**RE: NOTICE OF DISAPPROVAL
FINAL RCRA FACILITY INVESTIGATION REPORT ADDENDUM FOR
MELROSE BOMBING RANGE
CANNON AIR FORCE BASE, NEW MEXICO
EPA ID NO. NM5572124456-1
HWB-CAFM-03-001**

The New Mexico Environment Department (NMED) has reviewed Cannon Air Force Base's (the Permittee) response to the NMED's February 2006 Notice of Deficiency (NOD) on the *Final RCRA Facility Investigation Report Addendum for Melrose Bombing Range* (Addendum) dated February 2003. NMED has determined that the Permittee's response is technically deficient. The following response evaluation comment numbers correspond to the comment numbers in the Permittee's NOD response.

**FIGURE 2-8
AOC-2 SITE MAP**

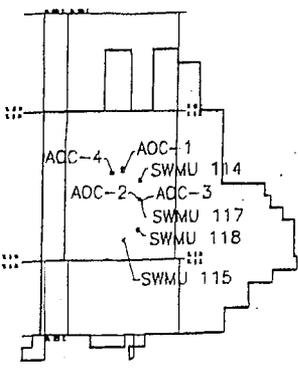
In addition to the above, the work plan must provide for soil field screening and visual inspection of debris at the site. Unless information is furnished that suggests additional investigation and characterization in these areas is not necessary, test pits approximately 6 to 10 ft deep must be excavated at AOC 2 (SWMU 131) at the locations of the sparse or absent vegetation shown on Figure 2-6 of the Addendum to check for waste. Two samples from the east sparse vegetation area, one from each of the other three sparse vegetation areas, and two from the area where vegetation is absent must be collected. All soil samples collected from these areas shall be analyzed for RCRA metals, VOCs (EPA 8260), semi volatile organic compounds (SVOCs), PCBs, dioxins and furans. A map depicting the recommended sample locations (labeled as Figure 2-6) is provided as Attachment 2 to this document.

*One sample
At truck loading
point*

Recommended Sampling location
